STAFF FINDINGS:

I move that the Commission issue a certificate of appropriateness for the application at 553 South Seventh Street, a contributing property in the Old West Side Historic District, to add a 442-square foot rear addition with the footprint as shown on drawing Sheet 10 of the submitted plans. As proposed, the work is compatible in exterior design, arrangement, texture, material and relationship to the rest of the building and the surrounding area and meets *The Secretary of the Interior's Standards for Rehabilitation* and *Guidelines for Rehabilitating Historic Buildings*, in particular standards 2, 5, 9, and 10 and the guidelines for building site and additions, as well as the *Ann Arbor Historic District Design Guidelines* for all additions and residential additions.

HISTORIC DISTRICT COMMISSION
PROJECT REVIEW

Hewitt Residence
553 S. 7th St.
Ann Arbor, Mi 48103

Proposed Site Plan
SCALE: 1" = 20'

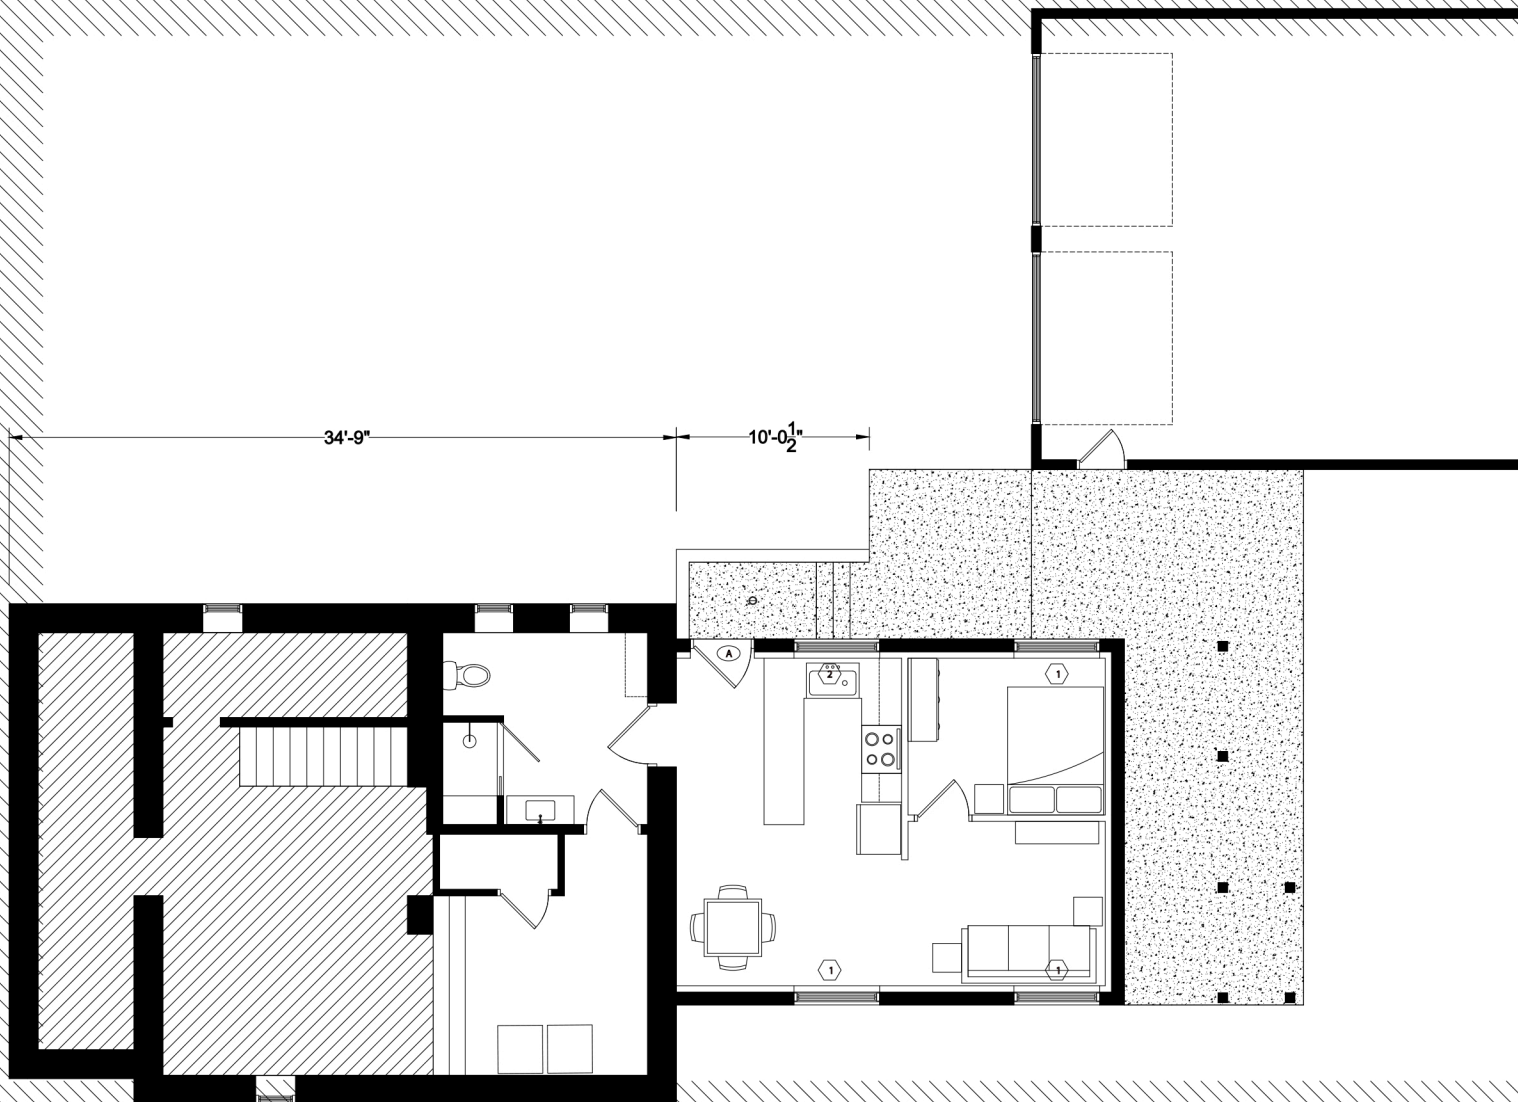
4. The addition is inset from both rear corners of the house – dimensions are not shown, but on sheet 10 they appear to be about 5' on the south and 2' on the north. The work will be visible from both sides, though more prominently on the north along the driveway.

7. The sample motion below states that the addition's footprint will be as shown on drawing sheet 10. This is because the dimensions on sheet 6 are larger (leftover from a previous version). The word "drawing" was inserted before "sheet 10" because there is another sheet 10 with text only at the end of the packet.
